Access Compliance Report

Public Rights-of-Way (Curb Ramps)

Intersection ID: 48147	Main Street: MCCAMEY_DR	Cross Street: FRANKLIN_MEADOWS_DR	Location: NE
ADA ID: CB2C66B7B805	Ramp Type: Perp	Initial Pass/Fail: Pass	Overall Compliance: No
		Severity Score: 2.75

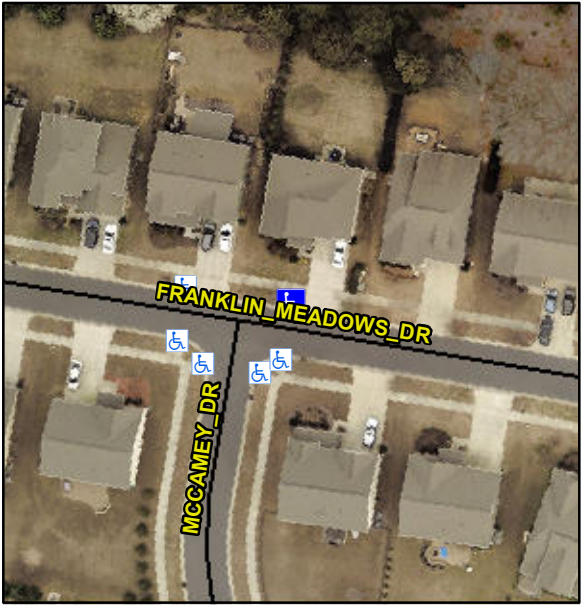
Codes/Mitigation Info/Possible Solution			Field Measurements/Component Compliance		
	Possible Solutions:		Compliance	Description	Data
	Remove & Replace Entire Ramp.		Yes	Ramp Length (in)	94.5
			No	Ramp Width (in)	54.5
			Sloped	Flare Type LT	N/A
			Yes	Flare Slope LT (%)	4.9
			Yes	Flare Traversable LT?	Yes
			Yes	Landing Length (in)	60.0
			Yes	Landing Width (in)	54.5
			Yes	Landing Slope (%)	1.5
			No	Landing X Slope (%)	1.2
<p>Surveyor Notes:</p> <p>N/A</p> <p>PROW/ADA:</p> <p>R304.5.3, R305.1.4, R305.2</p>			No	Landing Curb? (Y/N)	No
			No	Shared Landing?	No
			No	Gutter Ponding?	No
			Yes	Gutter Lip Ht (in)	0.0
			No	Painted X Walk1?	No
				X Walk 1 Direction	To S
			N/A	X Walk 1 Width (in)	N/A
				X Walk 1 Slope (%)	3.6
				X Walk 1 X Slope (%)	0.5
			N/A	Ramp inside XWalk1?	N/A
			N/A	Road Slope (%)	N/A
			N/A	Road X Slope (%)	N/A
			Yes	Any Obstructions?	No
				Obstruction Type	
			N/A		
			Yes	Surface Condition? (G/P)	Good
